Form C-147
Revised April 3, 2017

Recycling Facility and/or Recycling Containment

From: Smith, Cory, EMNRD
Sent: Wednesday, April 10, 2019 1:27 PM
To: Andrea Felix
Cc: Powell, Brandon, EMNRD; Billings, Bradford, EMNRD
Subject: 3RF-28 &29 Modification Request

Enduring Resources IV, LLC
WLU Unit 2309-24N Recycling Facility / Containment
#3RF-29
Modification

Upper leak detection system: (New)

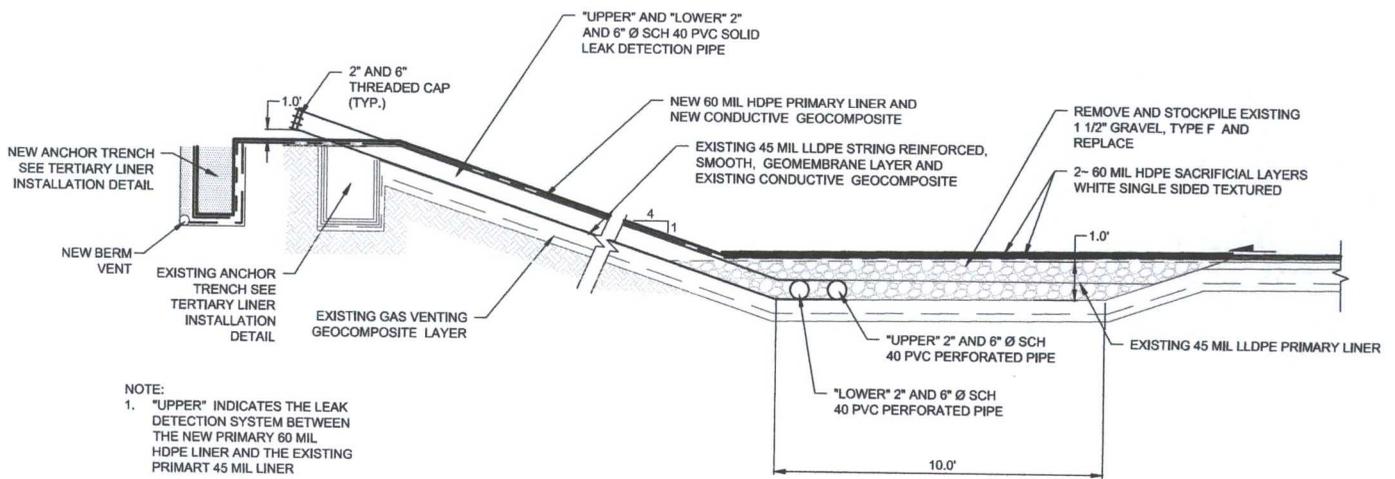
Modification to Leak Detection: Addition of a second leak detection system.

The leak detection system between the Primary (new) and the secondary (existing) lower geomembrane liner consists of a 200-mil geo net to facilitate drainage. The leak detection system consists of a properly designed drainage, collection and removal system placed above the secondary (existing) geomembrane liner in depressions and sloped to facilitate the earliest possible leak detection. A 3-foot-wide by 3-foot-long by 2-foot-deep depression will be constructed to allow for collection of any leaking liquid. A 2-inch and 6-inch PVC pipe will be installed in between the primary (new) and secondary (existing) liners from the top of the containment depression to allow for detection and removal of

PRODUCED WATER PIT
LEAK DETECTION
 N.T.S.

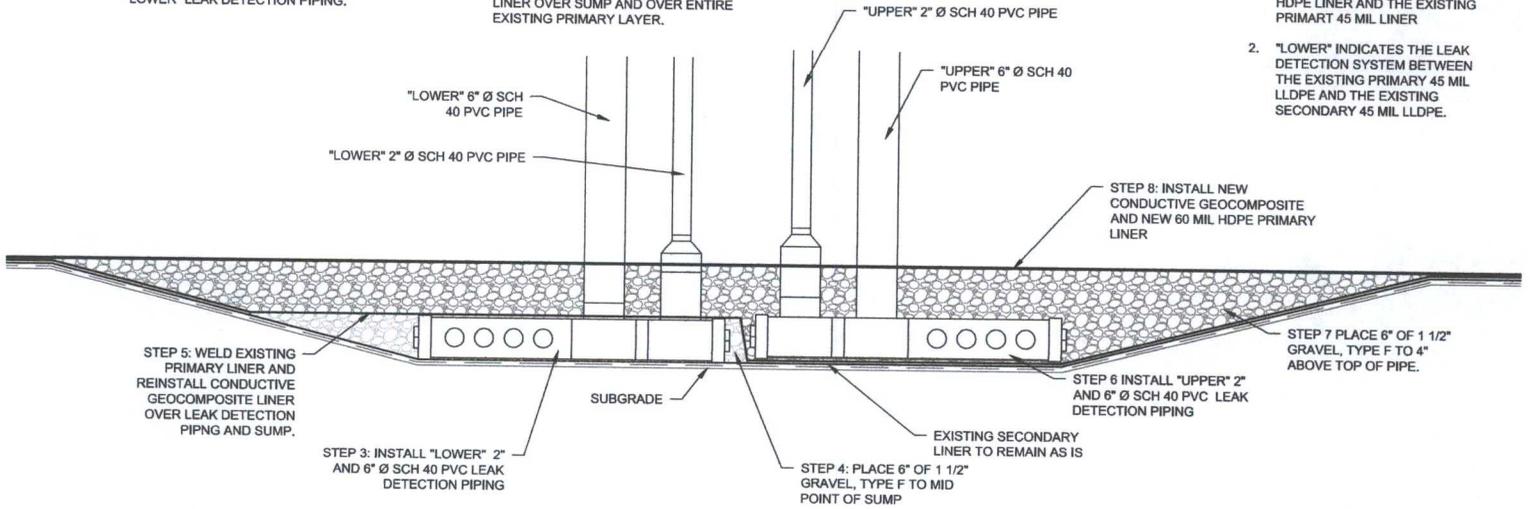
- NOTE:
1. "UPPER" INDICATES THE LEAK DETECTION SYSTEM BETWEEN THE NEW PRIMARY 60 MIL HDPE LINER AND THE EXISTING PRIMARY 45 MIL LINER
 2. "LOWER" INDICATES THE LEAK DETECTION SYSTEM BETWEEN THE EXISTING PRIMARY 45 MIL LLDPE AND THE EXISTING SECONDARY 45 MIL LLDPE.

1. SLIT EXISTING PRIMARY LINER TO ACCESS GRAVEL FILLED SUMP AND INSTALL NEW LEAK DETECTION PIPING.
2. REMOVE 1 1/2" GRAVEL TYPE F AND STOCKPILE.
3. INSTALL "LOWER" LEAK DETECTION PIPING INTO SUMP.
4. PLACE 6" OF 1 1/2" GRAVEL TYPE F TO TOP OF "LOWER" LEAK DETECTION PIPING.
5. WELD EXISTING PIT LINER SLIT. PLACE EXISTING PRIMARY LINER OVER "LOWER" LEAK DETECTION PIPING AND GRAVEL.
6. INSTALL "UPPER" LEAK DETECTION PIPING.
7. PLACE 6" OF 1 1/2" GRAVEL, TYPE F TO TOP OF "UPPER" LEAK DETECTION PIPING PLUS 4".
8. PLACE NEW CONDUCTIVE GEOCOMPOSITE OVER SUMP AND EXISTING POND PRIMARY LINER. PLACE NEW 60 MIL HDPE PRIMARY LINER OVER SUMP AND OVER ENTIRE EXISTING PRIMARY LAYER.

STEP 5: WELD EXISTING PRIMARY LINER AND REINSTALL CONDUCTIVE GEOCOMPOSITE LINER OVER LEAK DETECTION PIPING AND SUMP.

STEP 3: INSTALL "LOWER" 2" AND 6" Ø SCH 40 PVC LEAK DETECTION PIPING

STEP 4: PLACE 6" OF 1 1/2" GRAVEL, TYPE F TO MID POINT OF SUMP

STEP 6: INSTALL "UPPER" 2" AND 6" Ø SCH 40 PVC LEAK DETECTION PIPING

STEP 7: PLACE 6" OF 1 1/2" GRAVEL, TYPE F TO 4" ABOVE TOP OF PIPE.

STEP 8: INSTALL NEW CONDUCTIVE GEOCOMPOSITE AND NEW 60 MIL HDPE PRIMARY LINER
